AMENDMENTS TO THE DRAWINGS

Application No. 10/811,930 Amendment filed October 15, 2007 Reply to Office Action of July 13, 2007 Docket No.: 0465-1787PUS1

FIG. 6

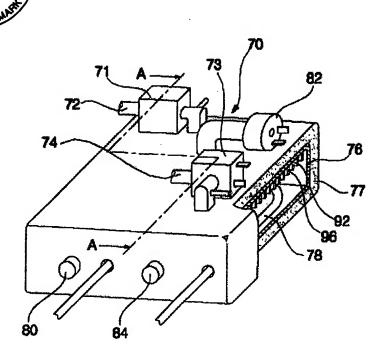
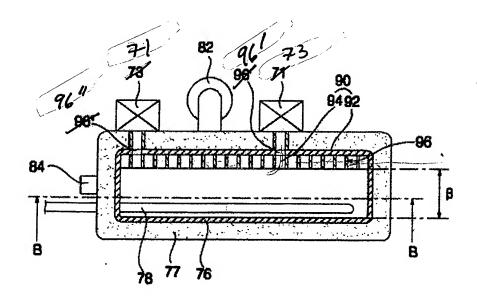
Second, the Examiner has objected to the drawings as they fail to show the correct cross-

sectional view taken along line A - A in FIG. 5. Applicants respectfully submit that the drawing

Third, the Examiner has objected to the drawings as they fail to show the reference

Fourth, the Examiner has objected to FIG. 7 as representing different descriptive features

when compared to FIG. 5. Applicants respectfully submit that the changes to FIGS. 6 and 7,

In FIG. 6, reference numerals 96' and 96" have been redrawn to be more legible, and reference numerals 71 and 73 have been reversed.

change to Fig. 6, where the reference numerals 71 and 73 have been switched, overcomes this

makes clear that the orientation of the holes in FIG. 7 is correct. Therefore, this objection is
